AMENDMENTS TO THE DRAWINGS:

REMARKS

Fig. 1
(PRIOR ART)

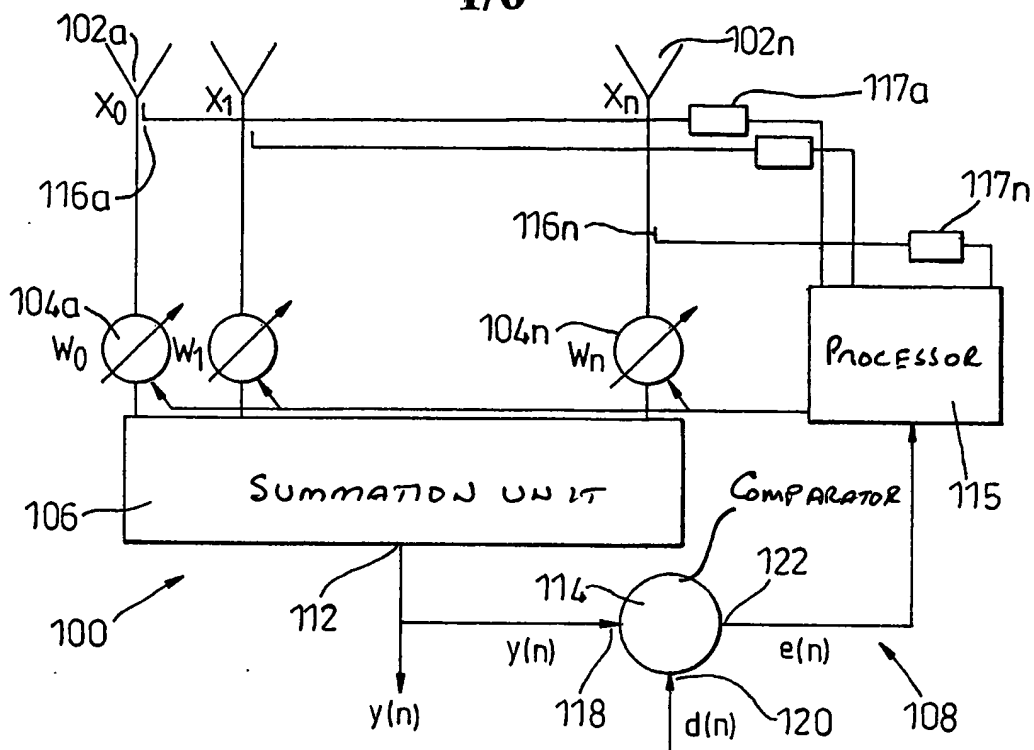
The examiner objected to the drawings for lacking descriptive text labels on Figures 1, 3-5A, 8 and 9.

The examiner objected to the drawings for lacking descriptive text labels.

Figures 1, 3-5A, 8 and 9 are amended to add appropriate textural references. The amended Figures include Figures 1, 3, 4, 5, 5a, 8 and 9. Marked up sheets of amended Figures are attached at Appendix A of this Reply. Four sheets of Replacement Figures are attached at Appendix B of this Reply.

Amended and Replacement Figures 1, 3, 5, 5a, 8 and 9, including appropriate textual references, are included at Appendix A and Appendix B respectfully of this Reply. The proposed drawing amendments are believed to overcome the examiner's drawing objections.
